PART 21 NOTIFICATION - DEFECTIVE HK AND K-LINE CIRCUIT BREAKER TENSION SPRINGS

Subject: 10 C.F.R. Part 21 Notification of Deviation re. P/N 716359A00 Tension Springs

HK Racking Mechanism Latch

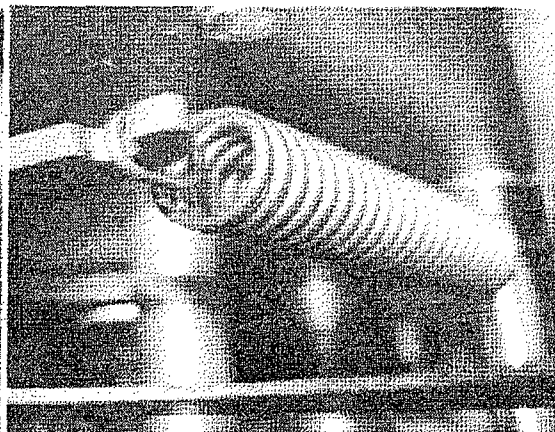
The identification of the Subject component is as follows: ABB P/N 716359A00 Tension Spring. These springs are used in both HK (Medium Voltage) and K-Line (Low Voltage) circuit breakers. In the HK breaker, the spring is used on the racking mechanism to position the racking mechanism interlock latch. In the K-Line circuit breaker, the spring resets the prop latch mechanism following a circuit breaker trip. See photos below:

Nature of the deviation: Micro-cracks in the base of the hooked end of the springs may result in failure of the springs after repetitive cycles. A broken spring could potentially affect the ability of a K-Line or HK breaker to reset and close after an opening operation. Initial report of the nonconformance was generated 2/11/2009 (NCR #68999II), reporting springs failed during mechanical life testing being performed on a K-Line Breaker. Three springs failed after approximately 2800 cycles each.

Given the large number of applications for the affected circuit breakers, ABB (Medium Voltage Service) cannot determine if the potential for a substantial safety hazard exists at any licensee's facility if a similar failure of the tension spring occurs. Licensees are requested to evaluate the history of inspections, maintenance practices, and circuit breaker operating cycles for K-Line breakers, and racking cycles for HK breakers to determine if the circuit breaker spring should be replaced immediately or at the next convenient maintenance opportunity. ABB recommends that any suspect spring with greater than 1400 operating cycles be replaced as soon as possible.

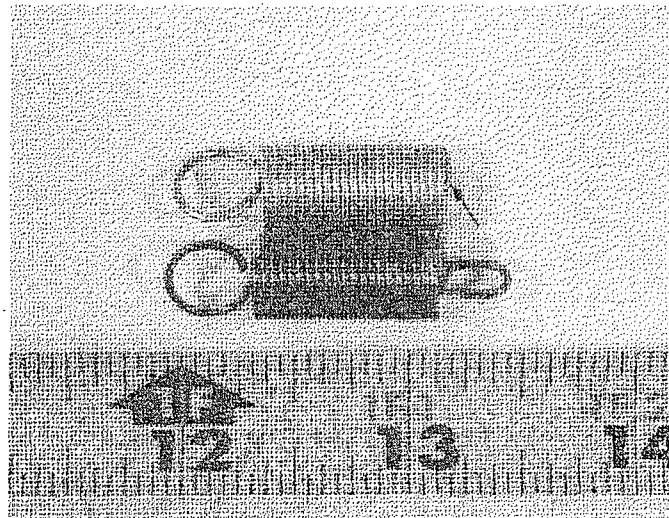
An additional issue was identified during the investigation in that the opposite end rectangular hook had tool marks from the forming operation that could result in premature spring failure. One spring failed after 6000 cycles in the concave bend area at this end. See photo below:

- c. Worked with our vendor, Ace Wire, to determine how future incidents can be prevented and developed quality assurance means to minimize the possibility of a recurrence. As of March 9, 2009, tooling has been polished to minimize tooling marks, and the fully formed hook will be made using the automatic forming machine on future orders.
